Oakton Community College District 535

Courtyard Rehabilitation

3. To include the following: ADDENDUM #2 CHANGE LOG FOR OAKTON COLLEGE COURTYARD REHABILITATION CITY OF DES PLAINES, ILLINOIS

Addendum #2 Change Log Oakton College Courtyard Rehabilitation

Sheet 4 – Grading Plan

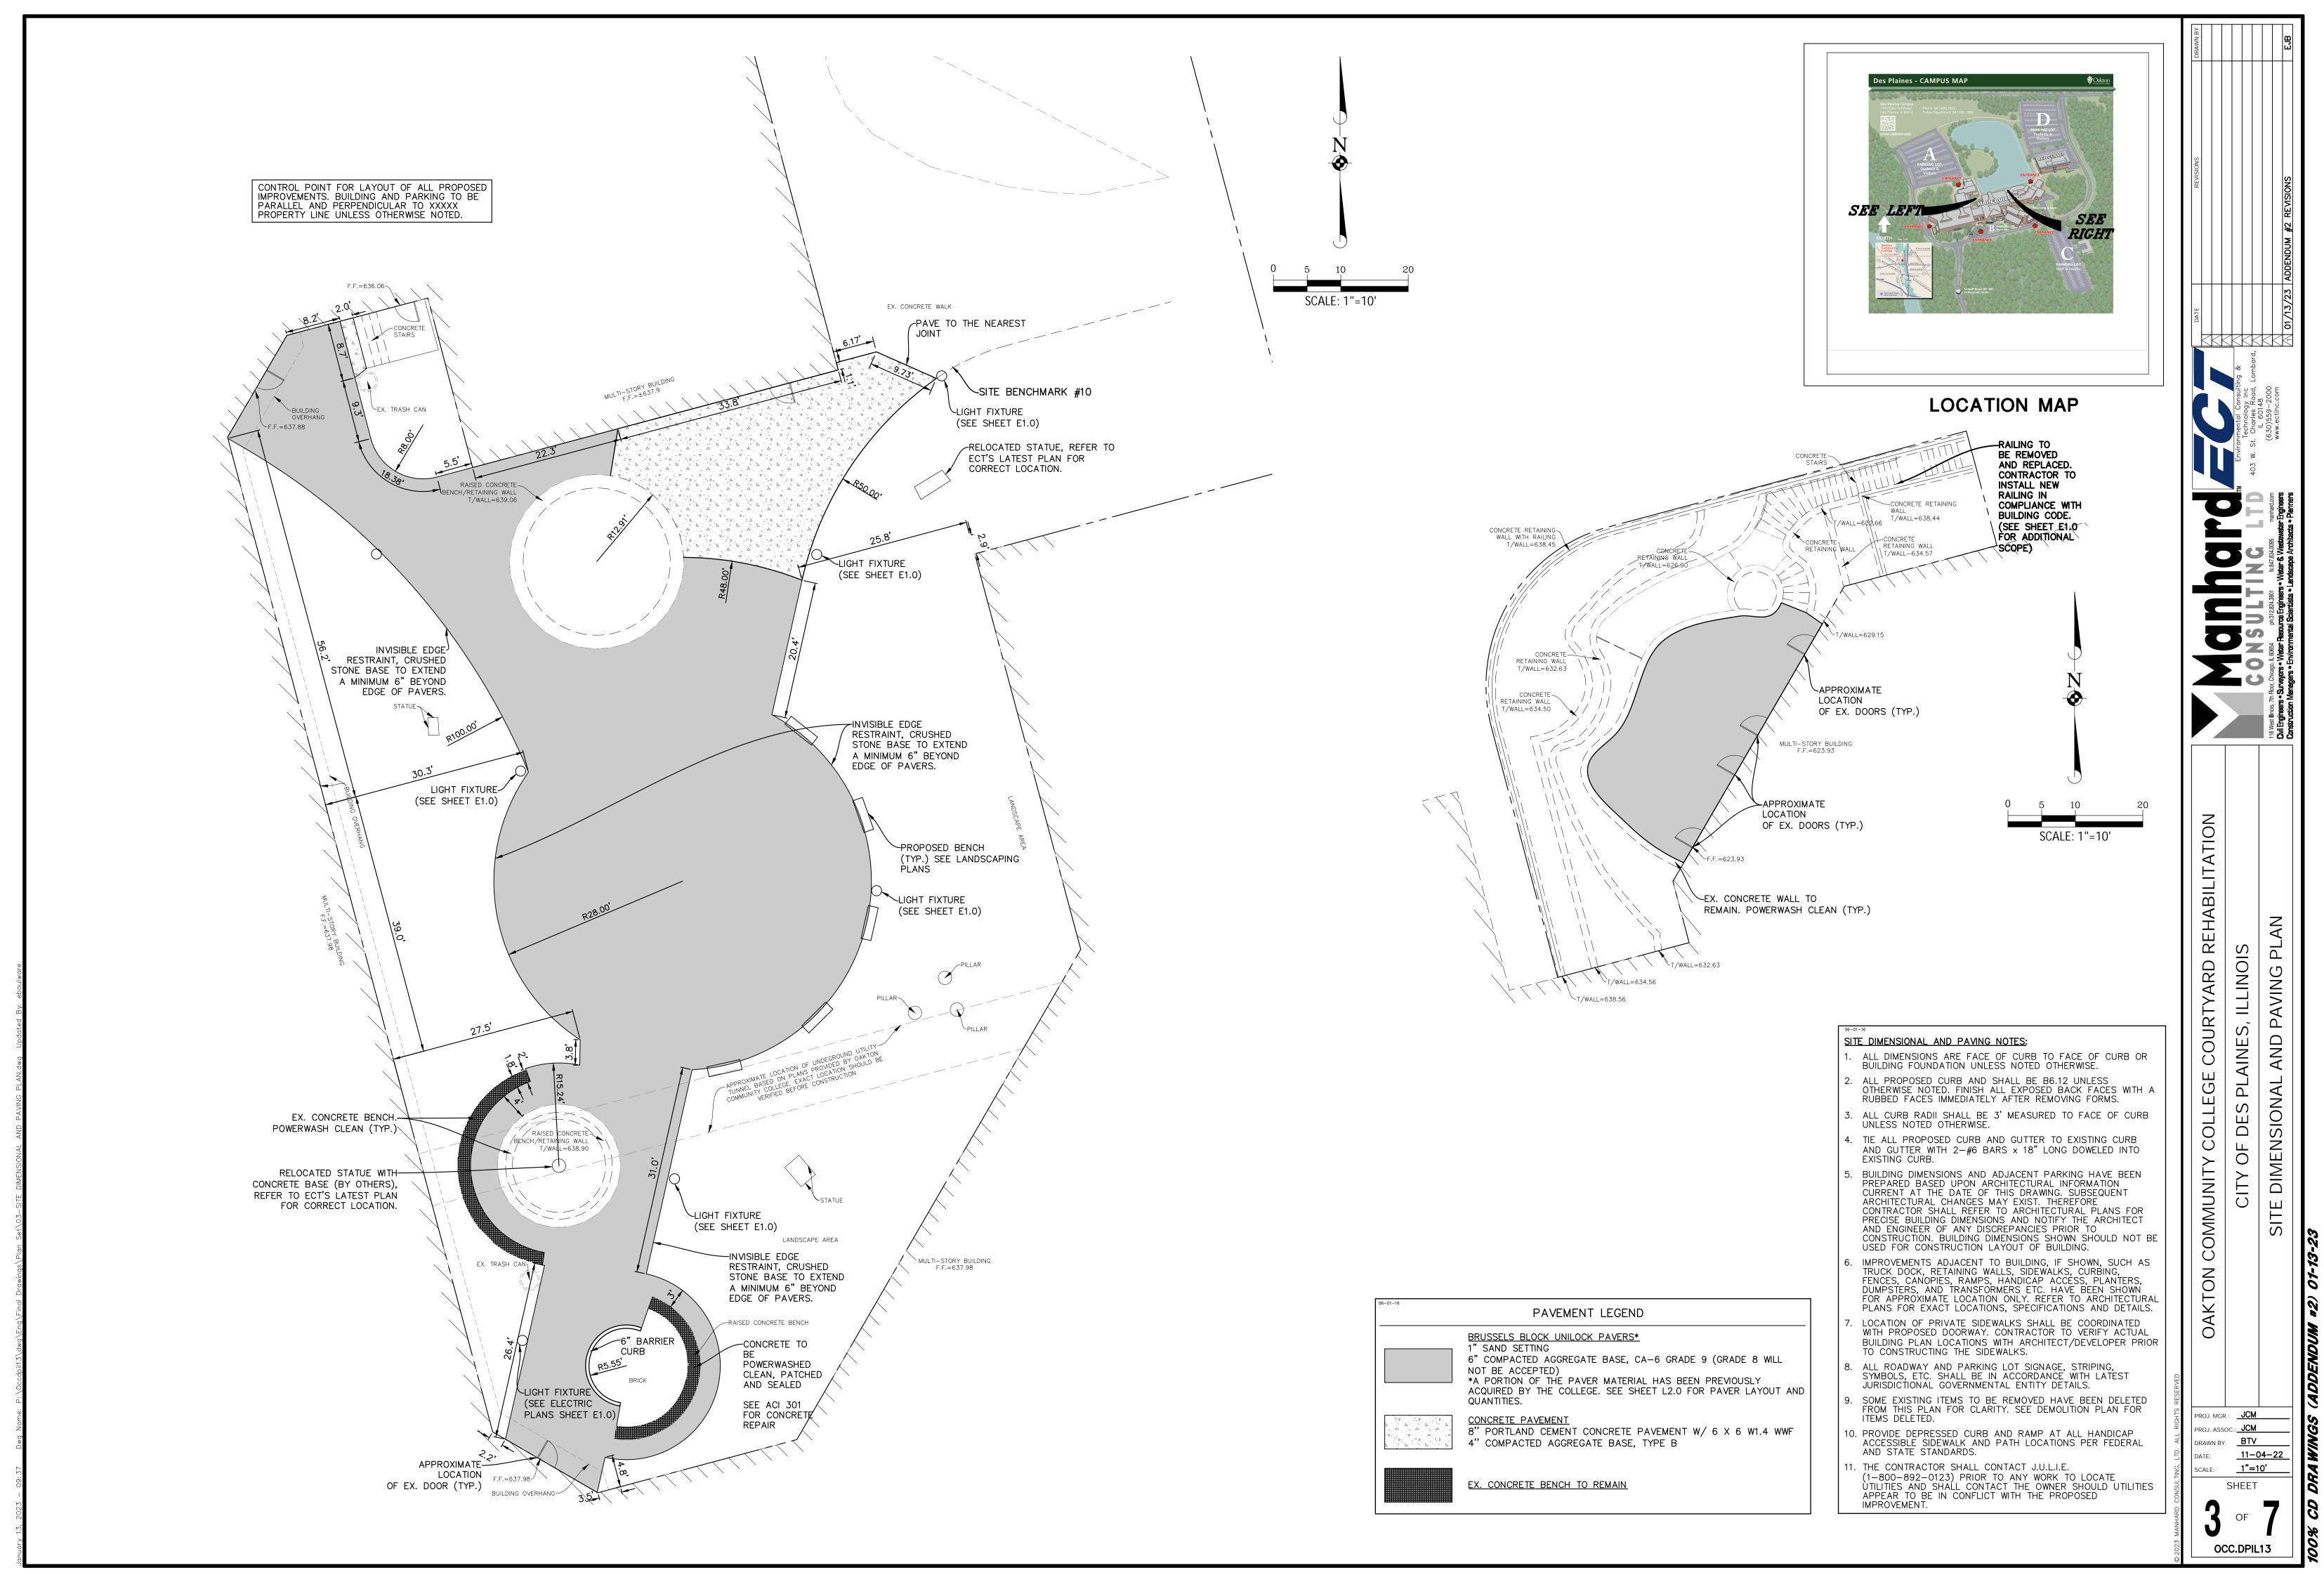
- Additional inlet protection added to proposed inlet southwest of central courtyard area.
- New weep holes to be drilled into concrete wall at locations where existing weepholes are blocked by new paver layout in lower courtyard area
- Alternate option calling for trench drains in lower courtyard to be removed and replaced if adjusting to grade is found to be infeasible
- Sanitary manhole in raised planter to be sawcut to proposed rim grade

Sheet 5 – Utility Plan

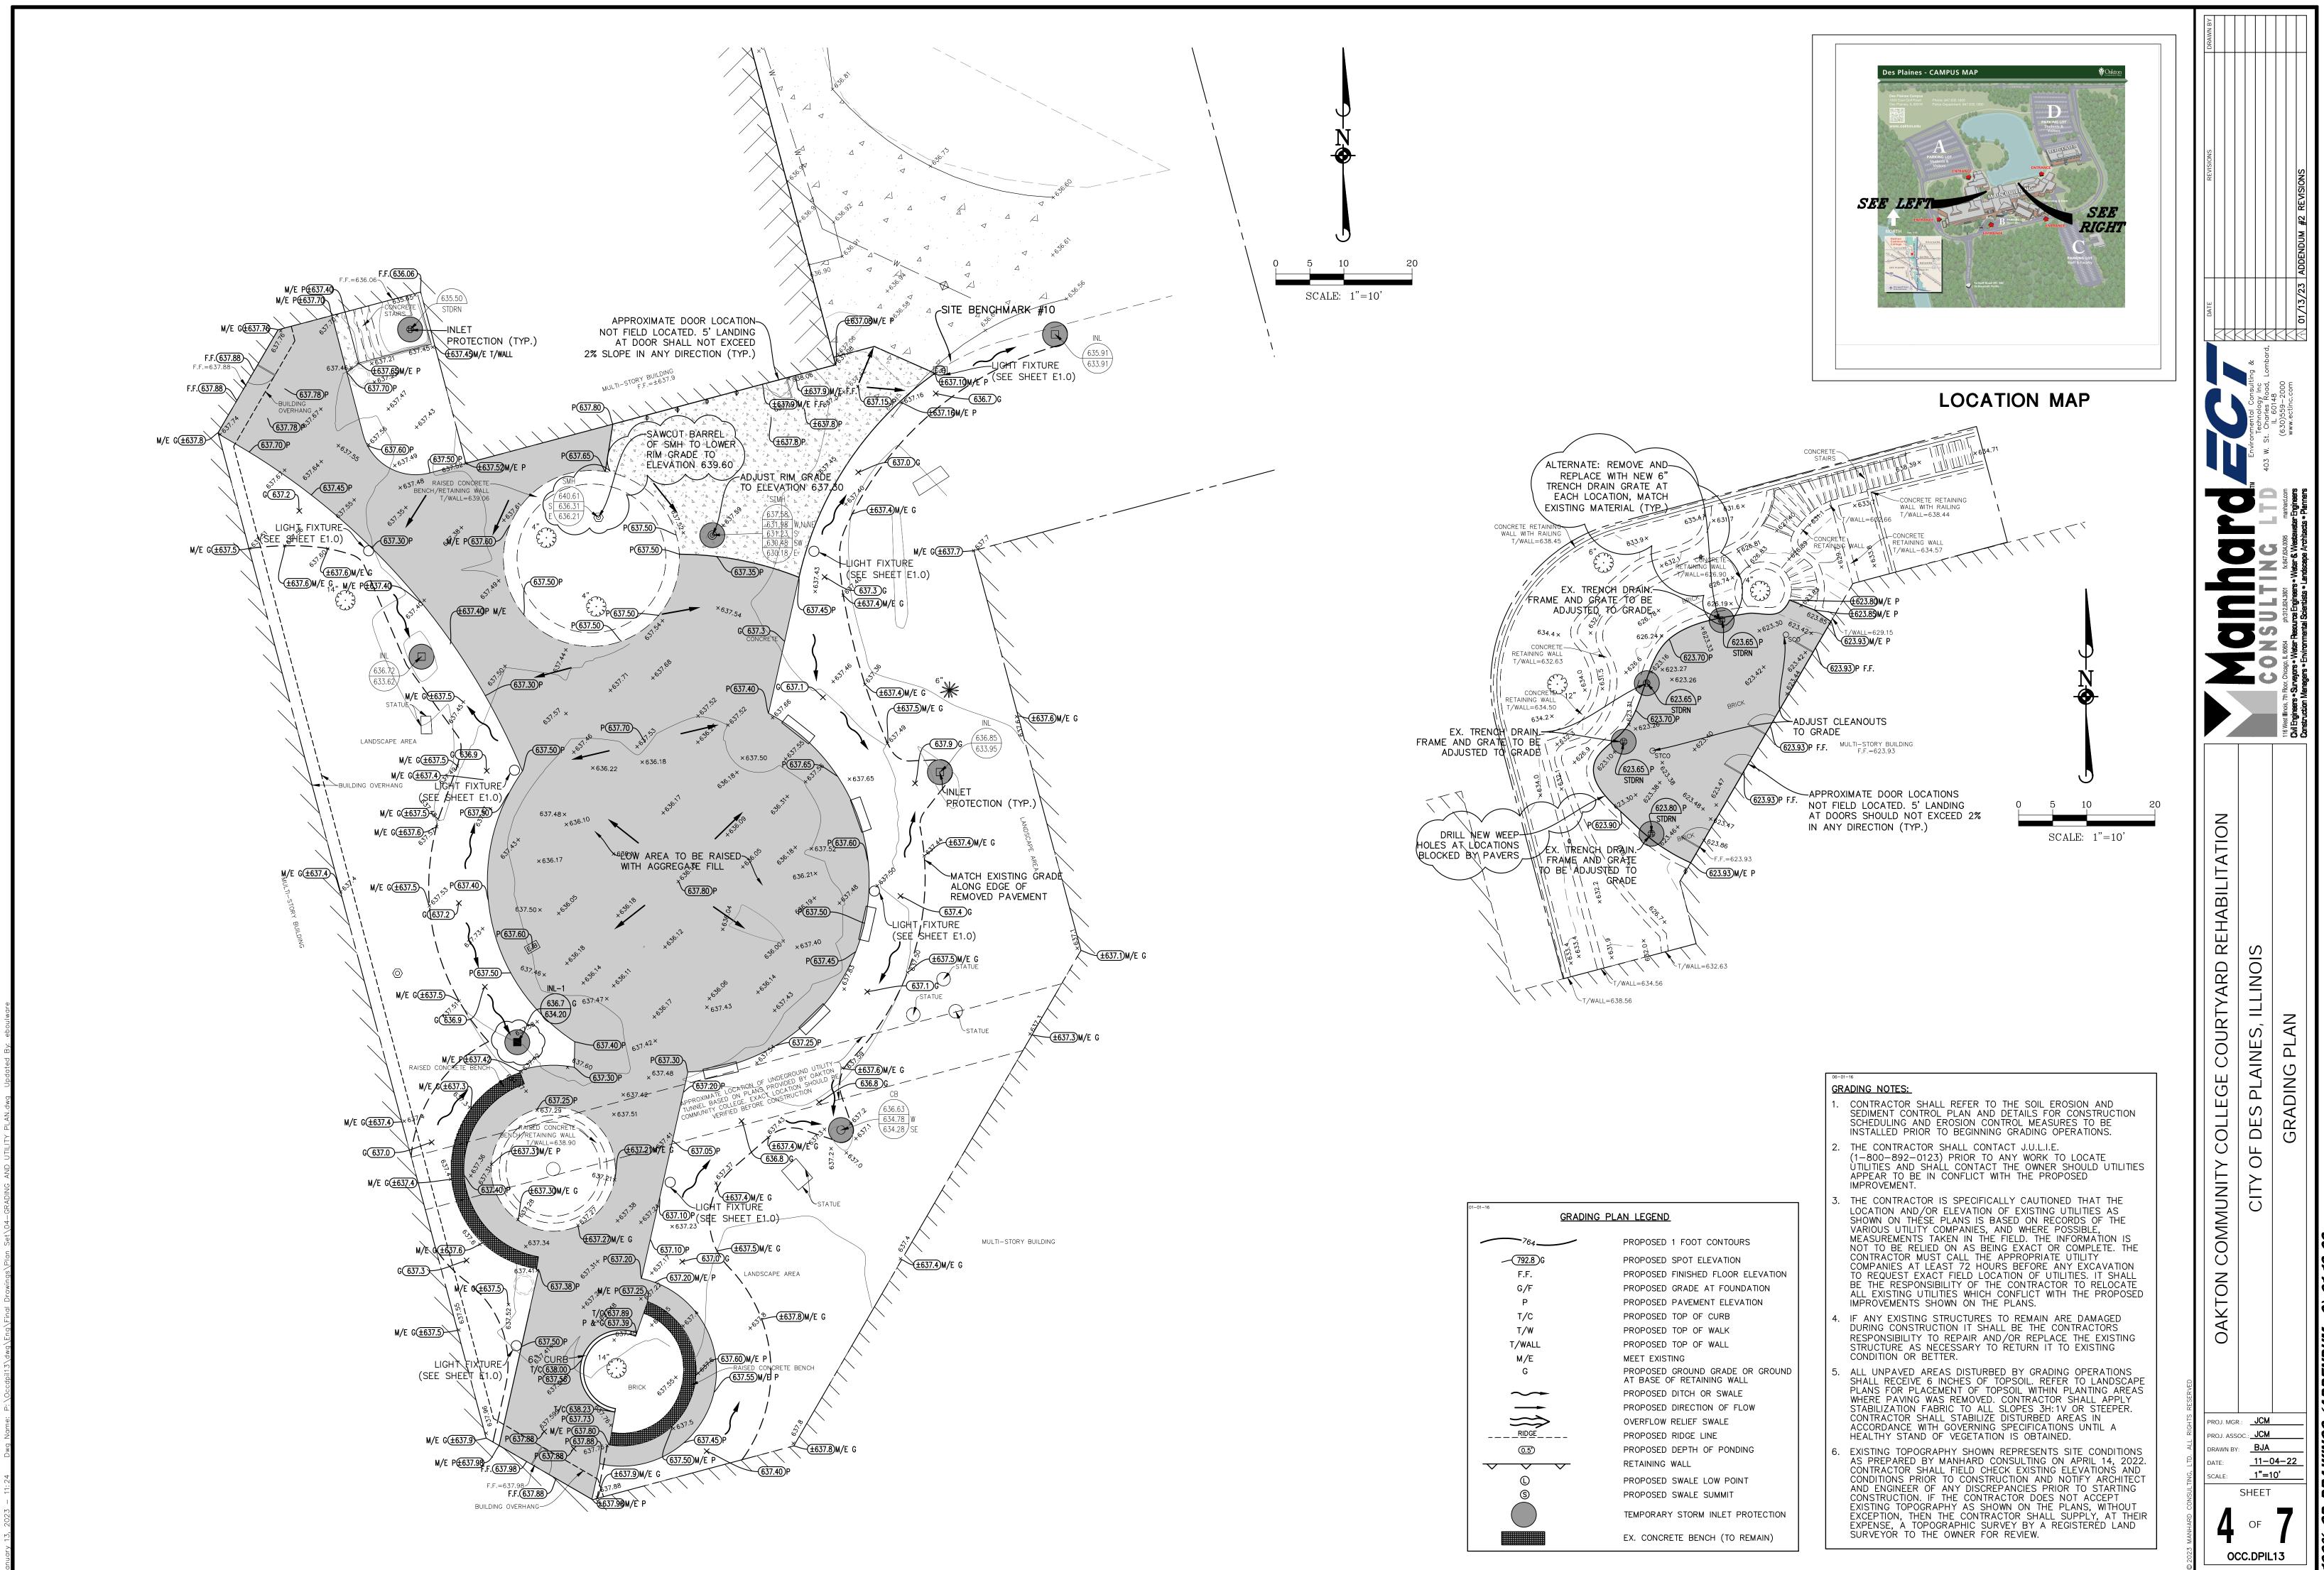
- Utility notes added for clarity
- Inlet proposed southwest of central courtyard area
- 44'-8" Storm line proposed to tee into existing storm under central courtyard area

Sheet 6 – Construction Details

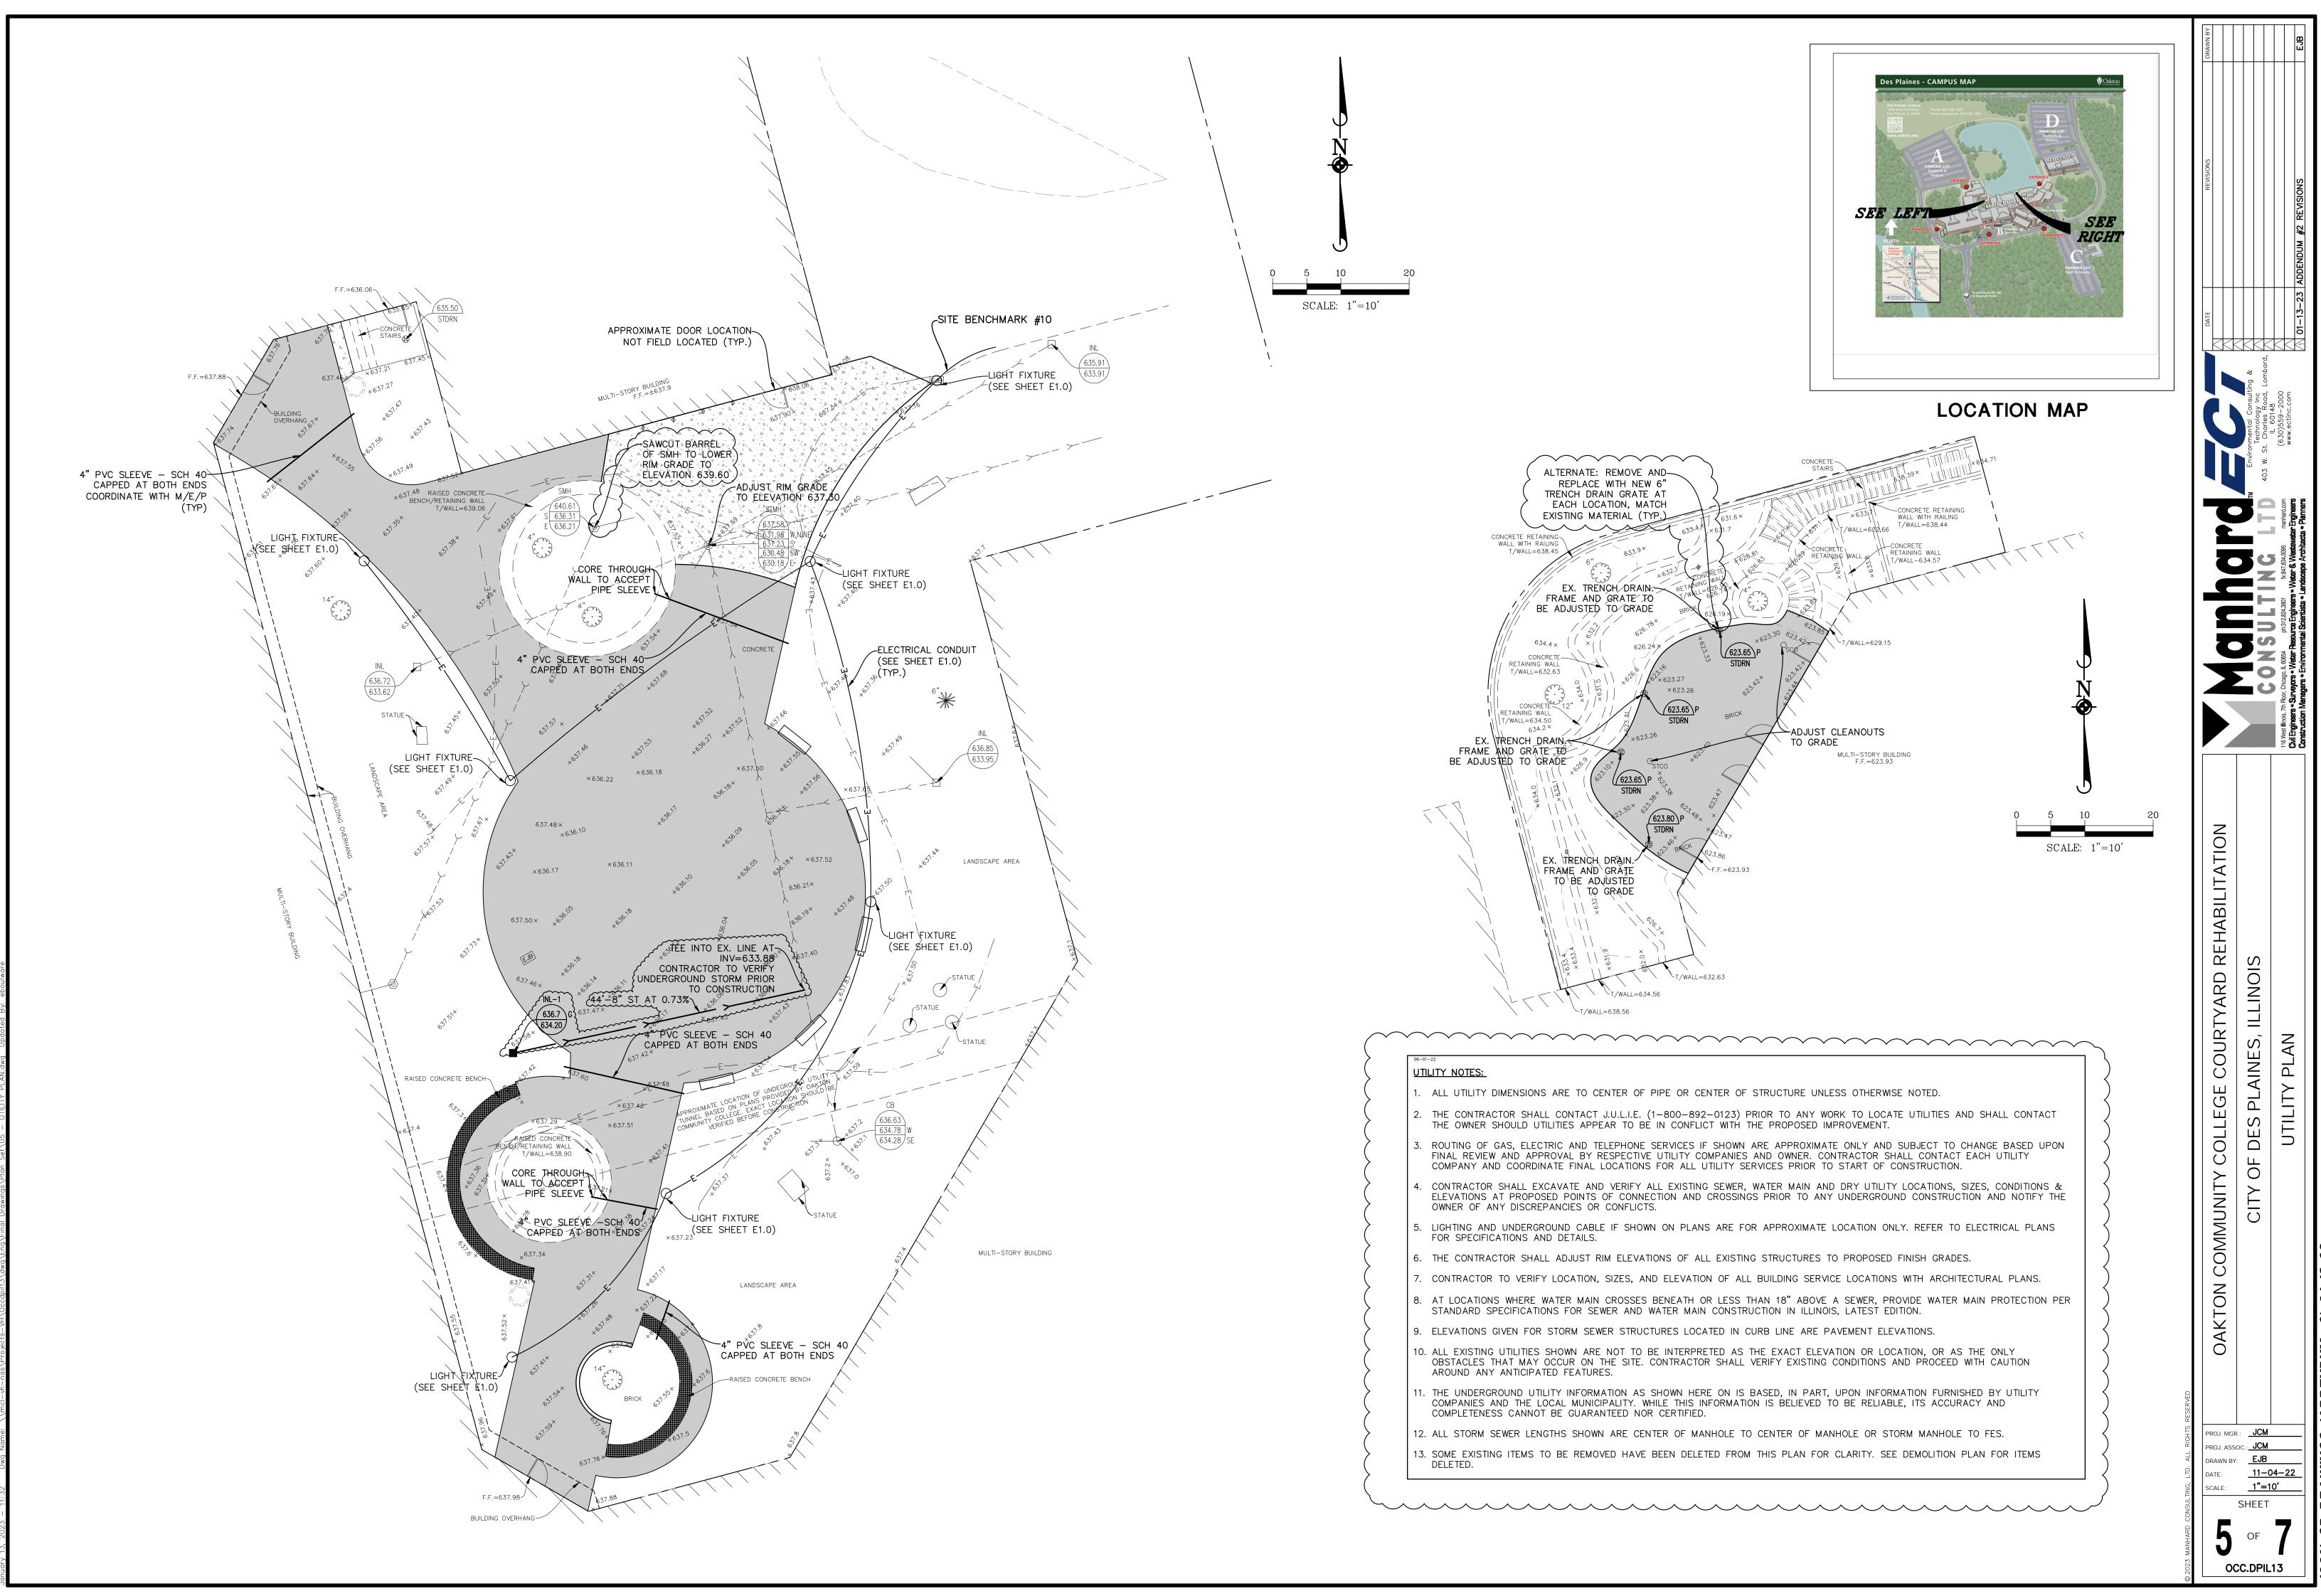
- Sidewalk detail added
- Inlet detail added
- Material standards detail added
- Pipe installation detail added
